Re: **ALLSUPS #102460**
Project #: PR-2021-006208
Application #: SI-2023-01171

Please find the following responses addressing comments received in a letter dated August 1, 2023. In an effort to address your comments concisely and simplify your review of these development plans, we have summarized your comments and our responses below. Your comment is listed first, followed by the response in Bold.

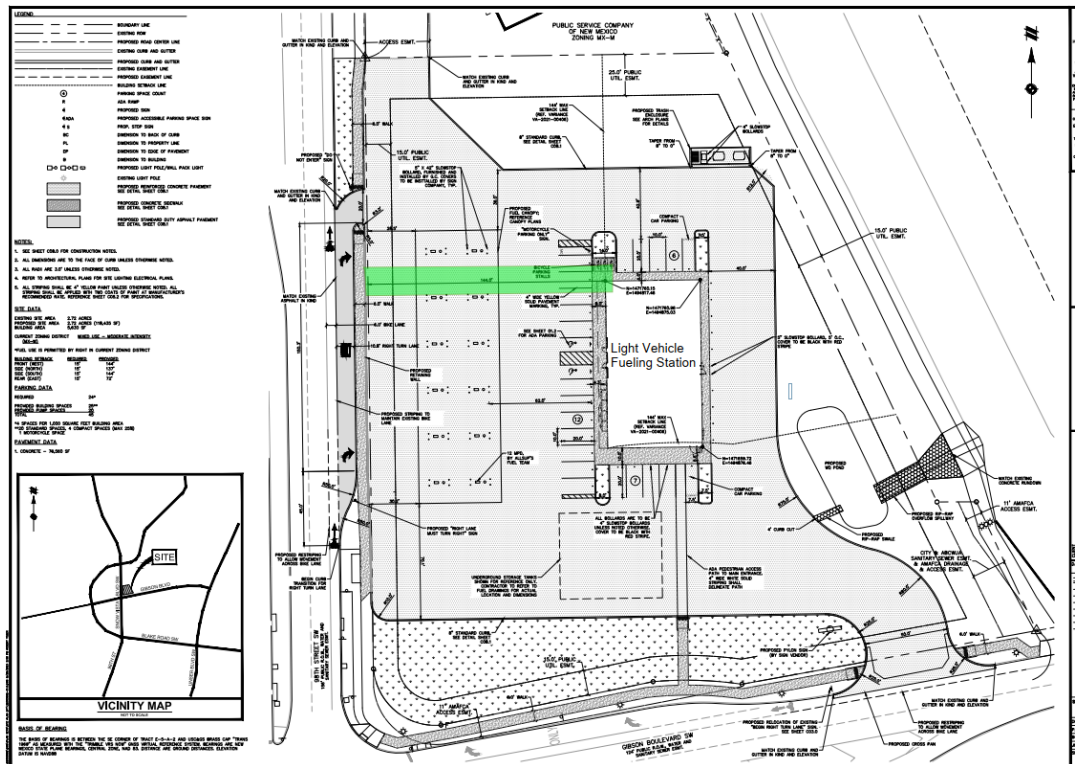
Comment 7: Please provide a detailed explanation letter and include site plan notes as to how the proposed elevation is meeting all applicable sections of 5-11(E) of the IDO.

Response 7: Below is the site plan and the measurements from the street facing façade to the property line. According to the IDO each street facing façade within 30 ft of a property line (the measurement shall be made to the closest perpendicular plane of a primary building façade) has to follow 14-16-5-11(E).

This site has 2 street facing façades (98th and Gibson). From the property line to the closest point on the street facing façade along 98th is approximately 144'. From the property line to the closest point on the street facing façade along Gibson is approximately 141.5'. Since the street facing facade exceeds 30ft from the property line 14-16-5-11(E) is not applicable.
